**TOWN OF HERNDON, VIRGINIA
HERITAGE PRESERVATION REVIEW BOARD
WORK SESSION AGENDA
JULY 3, 2019
HERNDON COUNCIL CHAMBERS BUILDING
765 LYNN STREET
7:00 P.M.**

Case Number & Type: HPRB #19-22; New construction
Case Summary: Construct new storage shed in the rear yard of a residential property
Case Location: 1026 Tyler Street, Van Vleck's Subdivision

Case Number & Type: HPRB #19-23; Alterations
Case Summary: Replace existing wood windows with new wood windows on a small rear addition/enclosure
Case Location: 753 Grace Street

Case Number & Type: HPRB #19-24; Alterations
Case Summary: Replace an existing three-tab asphalt shingle roof with a new architectural asphalt shingle roof on a single-family residential structure
Case Location: 920 Vine Street, St. Joseph's Catholic Church complex

PLAT
 SHOWING HOUSE LOCATION ON
 LOT 4, BLOCK 11
**D. VAN VLECK'S ADDITION TO THE
 TOWN OF HERNDON**
 (LIBER V-5, PAGE 252)
TOWN OF HERNDON, VIRGINIA
 FAIRFAX COUNTY
 SCALE: 1" = 30' APRIL 24, 2015 (STAKED LOT)

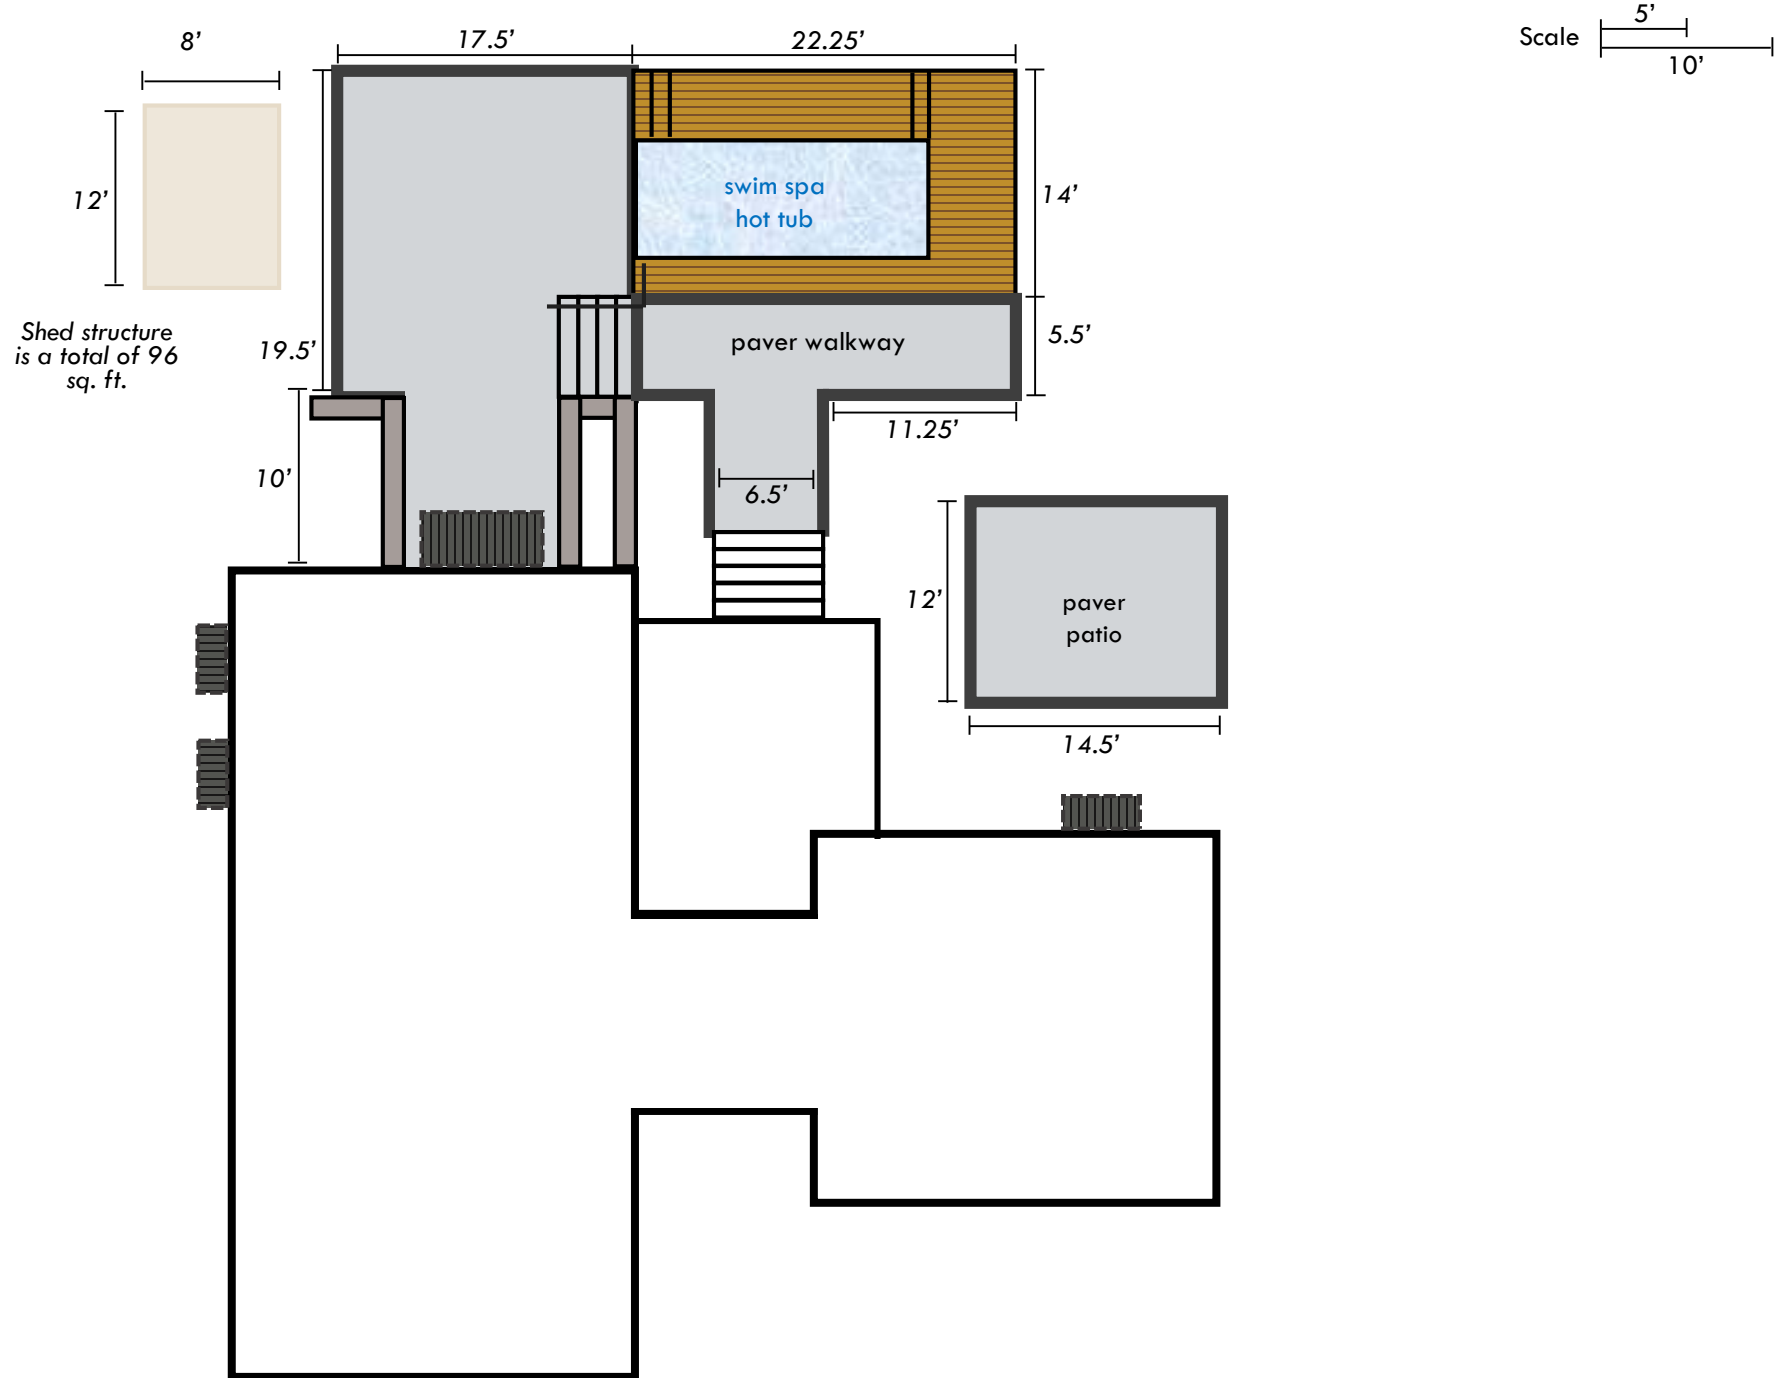
- 1) Information on size, material, color of wall trim around windows and doors, fascia, etc., as applicable
- 2) Information on size, material, color of doors and windows (to include lite divisions, as applicable)
- 3) Information on size, materials, and color of the shed cupola, including the roof materials, any vent materials, etc.
- 4) Dimensional information of the T1-11 siding (i.e. width and frequency of scored surface
- 5) Additional materials samples you can get a hold for the above items
- 6) Site plan showing dimensions of the shed, property boundaries and distances from property lines. We are not requiring a building location survey, however, we do need to ensure we can check and show zoning compliance for this accessory structure.

6. A site plan showing the proposed shed, its dimensions, the property boundaries, and the distances from our property lines is attached. The plat base image used for the attached site plan is from our refinancing in 2015 and it doesn't show the current conditions of the backyard project that we just completed. I'm hopeful that the site layout and pictures we provided with the original submission provide a good context illustrating how the shed serves as a symmetrical counterbalance to the swim spa on the opposite side of the lower patio. The area we're proposing for the shed has been reserved for this specific purpose since we began the design of this project in 2018.

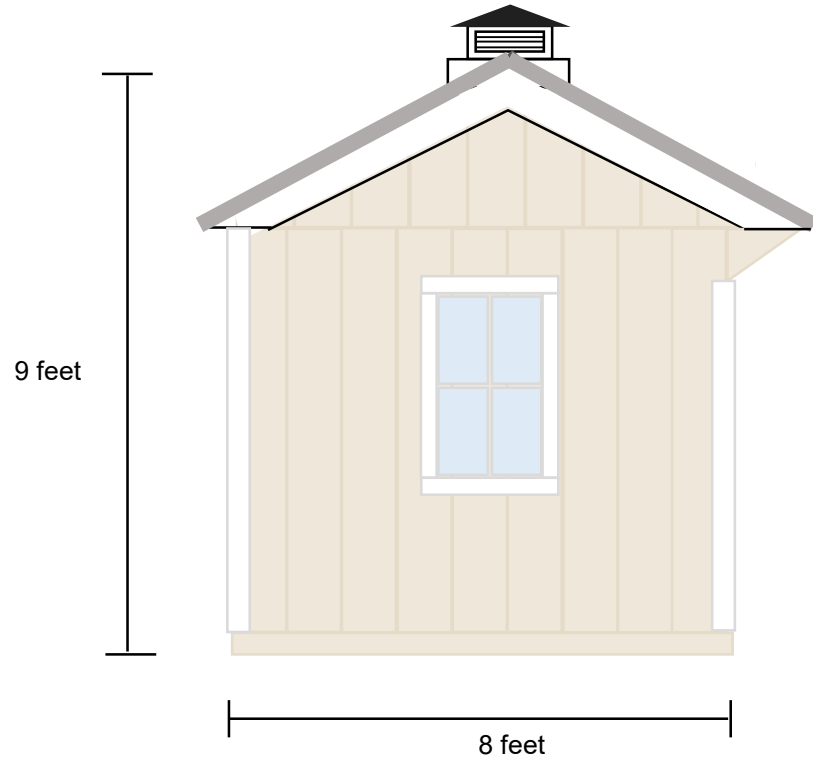
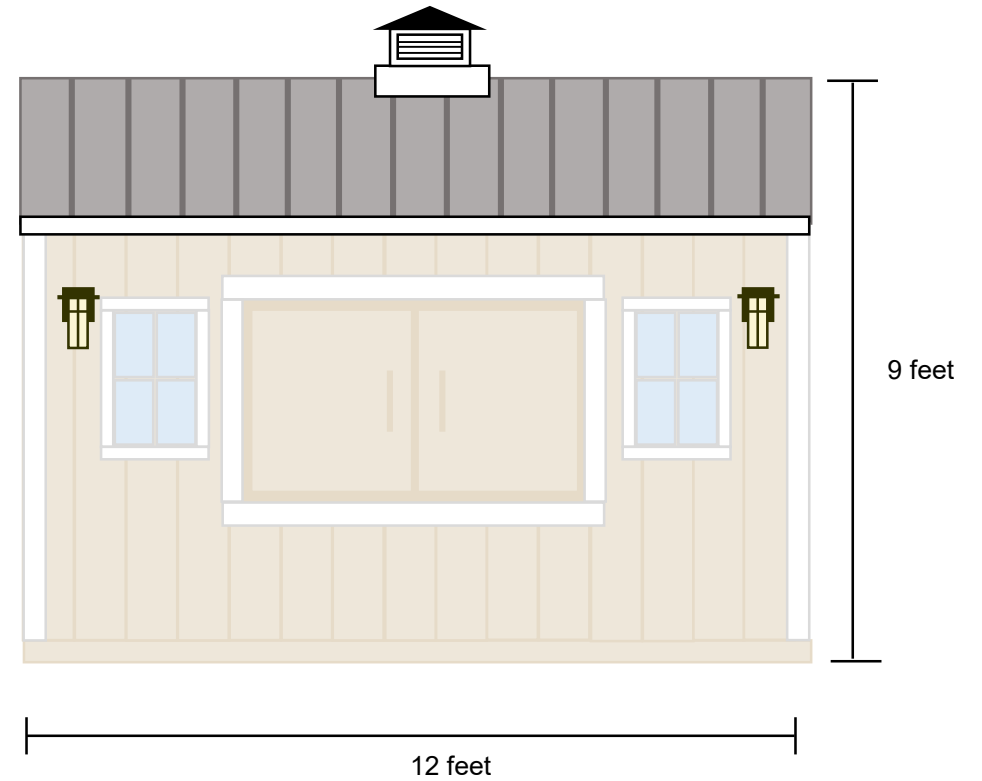
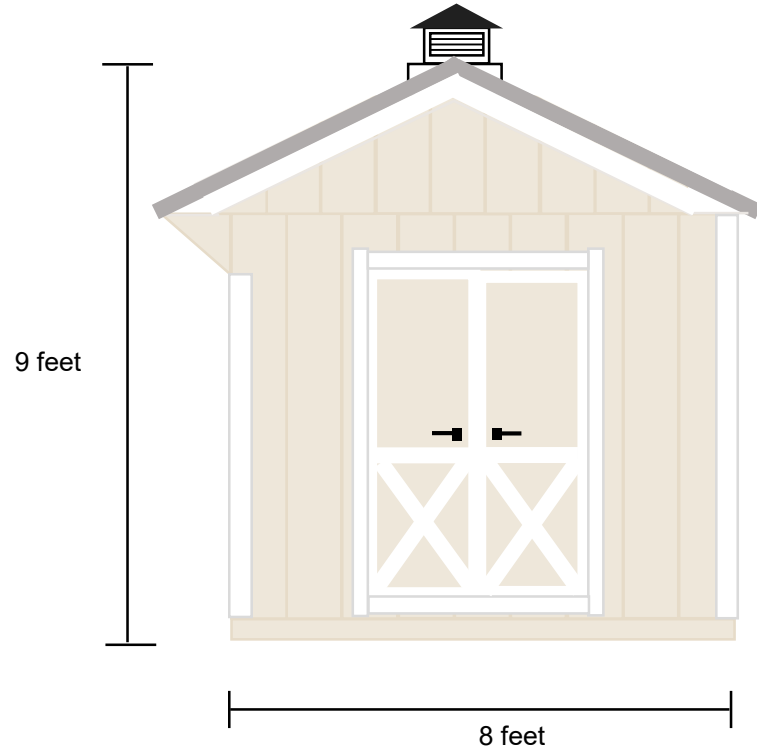
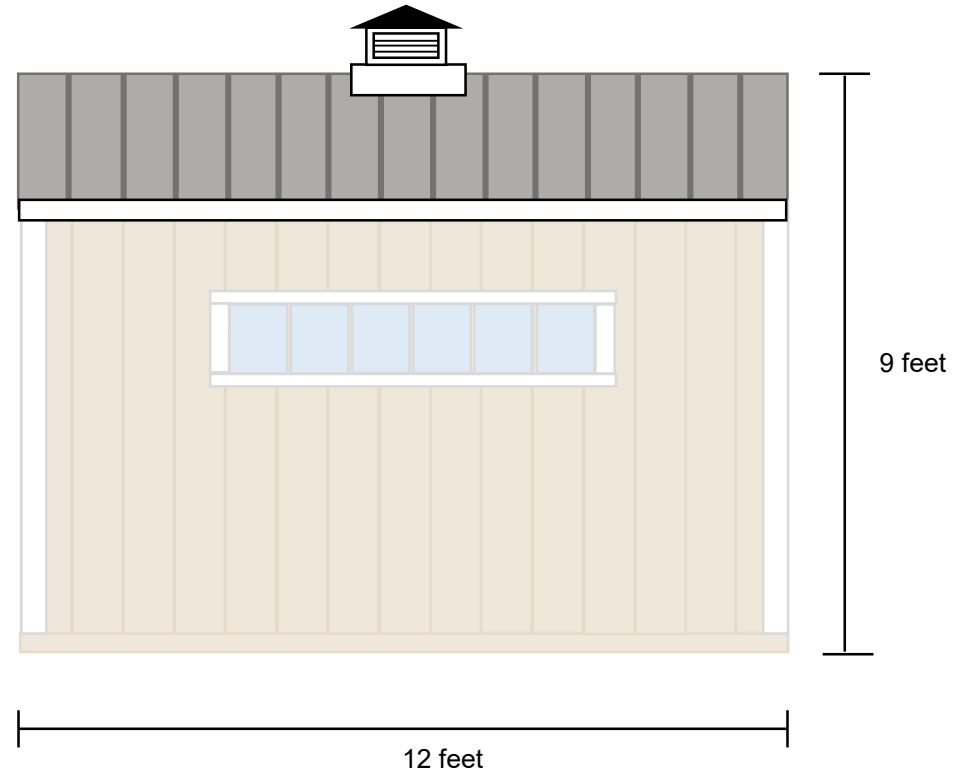
While staff finds the design to be in keeping with character of the non-contributing primary structure and it will not detract from the character of the district, several pieces of information related proposed design/materials need to be provided for clarity, which include:

- a) Detailed information on the materials/specifications of the proposed windows,
- b) Detailed information of the design/function related to the doors or enclosure of the 4’ X 6’ opening noted on the east elevation,
- c) Detailed information for the side wall and vent construction materials of the cupolas,
- d) Overall height of the structure with the cupola, and
- e) Foundation type and any associated covering of the foundation at or just above grade, if any.

The Board may also wish to discuss these items and such details as the window muntins/grill design. This may include the appropriateness of the proposed grill between glass grill design versus simulated divided lights or the use of wood windows with true pane divisions to complement the traditional design and wood product/materials proposed.

1. The wall trim is LP SmartSide Trim – 1" x 3";
2. There's a 4' x 6' covered opening on the south eave side with two 18" x 27" small windows (4 lite divisions, 2 over 2) on either side of the opening; a 4'8" wooden double door on the east gable side; a 72" x 11 ½" transom window (6 lite divisions, 6 over 1) on the north eave side; and a 24" x 36" standard window (4 lite divisions, 2 over 2) on the west gable side;

3. The shed cupola has a 21" square base and a 23" height with a black metal top; the roof is 28 gauge rolled stainless steel in a light grey color; and the vent will be incorporated into the roofline;

4. The T1-11 Duratemp siding has a 3/8" scored surface spaced every 8" on center;
5. Regrettably, our builder does not have additional physical samples to provide for our submission, however, he can send me pictures of the LP Smartside Trim, a standard window, and a 28 gauge rolled stainless steel roof – if this would be helpful, just let me know and I'll request them from our builder; and

HPRB SIGN ELEVATION

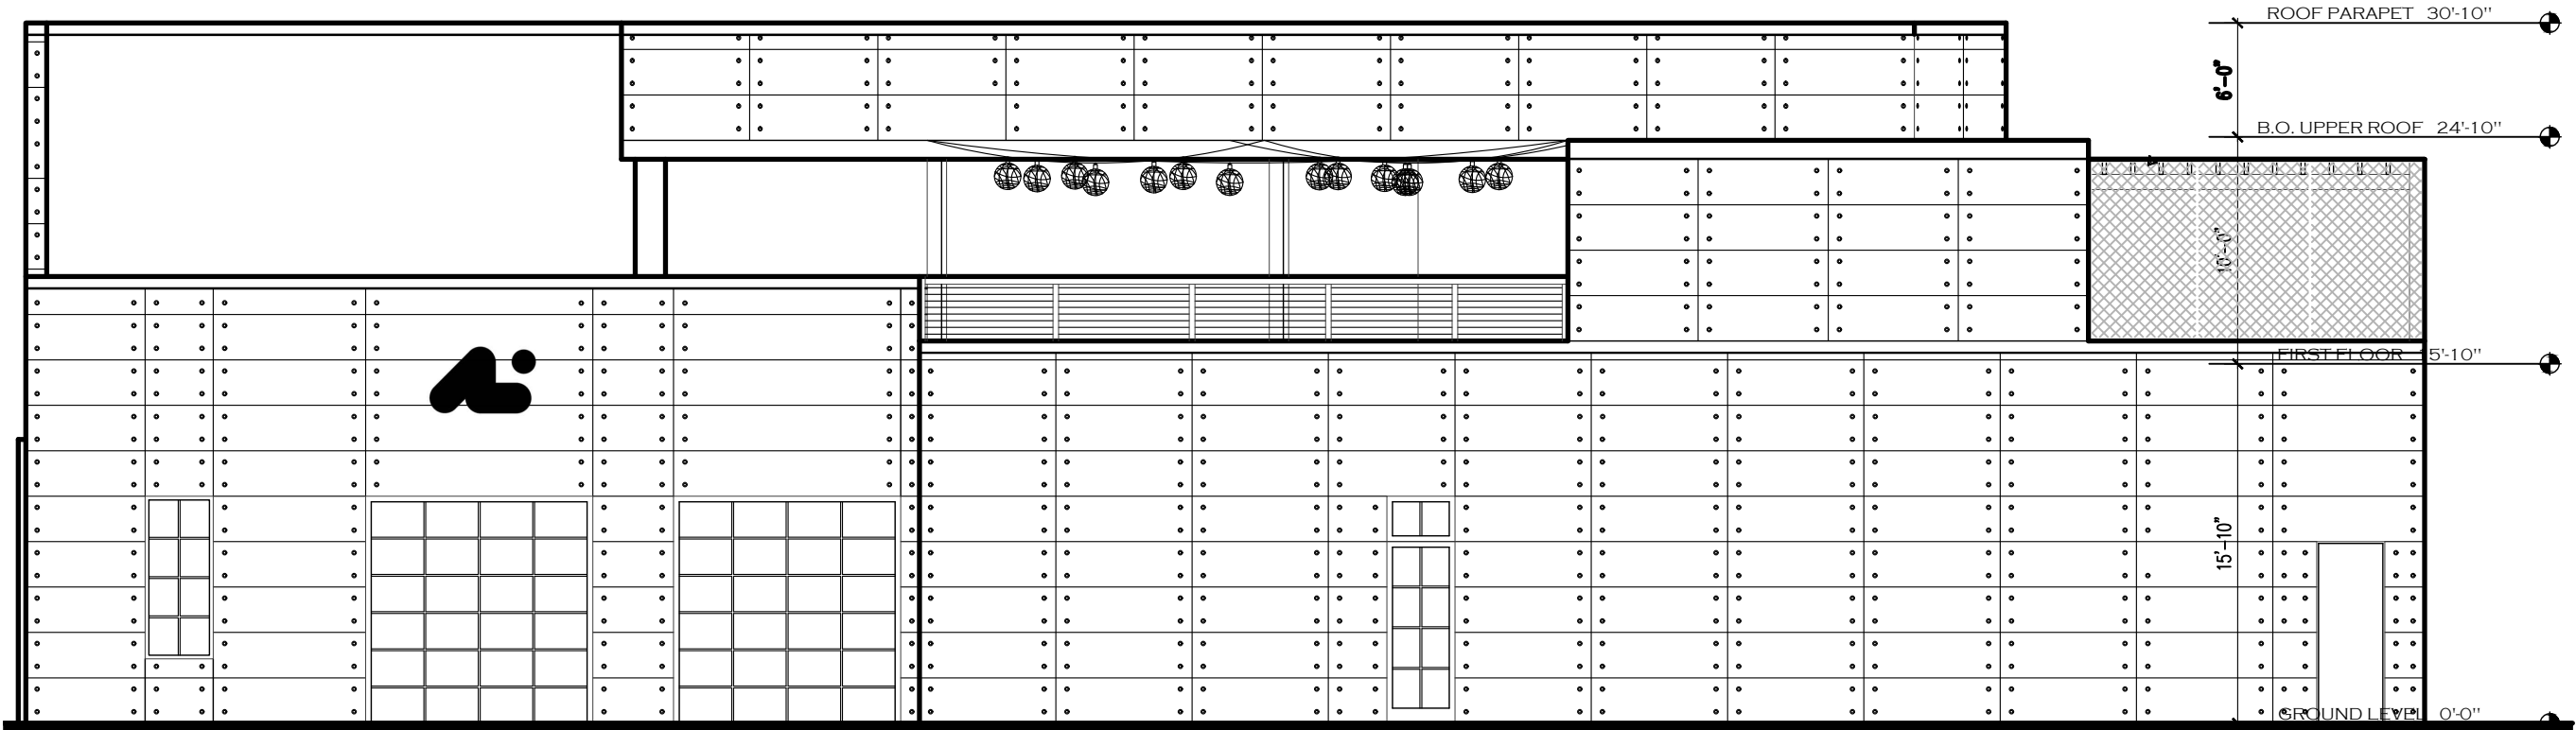
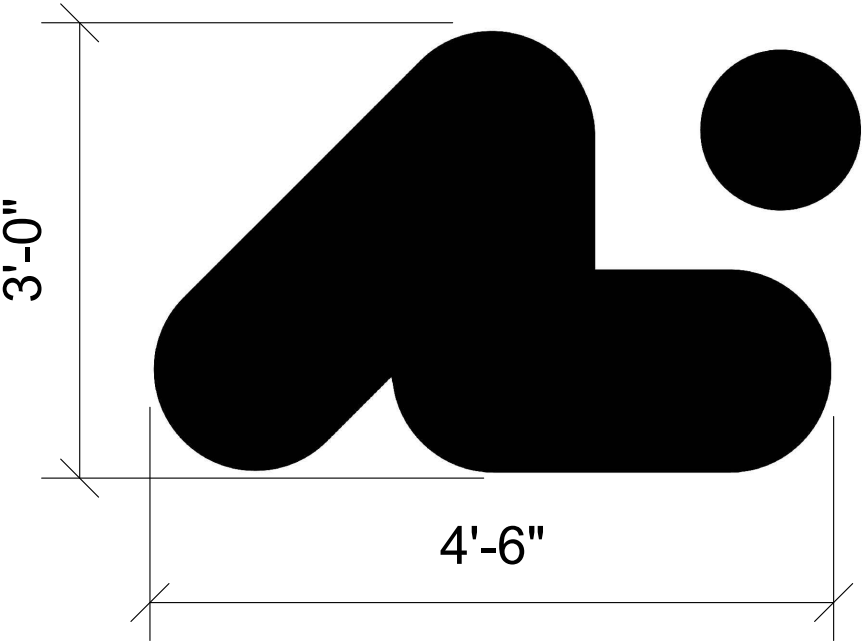
The second sign on the west elevation will be a unique business brand symbol constructed, mounted and lit using the same materials and configuration as the sign on the north elevation. This design is not clear in the applicant’s submission, however at the time of this report, staff has been working with the applicant’s representative to clarify this design in detail, and will expect to update the Board with additional design materials for review and discussion. This sign will be 3’-0” in height and 4’-6” in length and will be centered above a modular window system, 16’-6” above ground level, and approximately 21’-6” from the northwest corner of the building.

Staff has noted that additional goose neck lights may have been added on the north elevation along Elden Street as shown in the elevations within the HPRB #19-25 submission materials, which are different from the Board’s previous approvals. These potential deviations from the approved elevations shall be excluded from any approval of the proposed signage subject of this case.

If the applicant can revise the north elevation sign design to comply with the referenced zoning ordinance section before the July 17, 2019 Public Hearing, the Board may act on this case. As of the date of this staff report, the applicant's representative has stated that a revised design will be submitted to comply with the zoning ordinance for Board review and consideration.
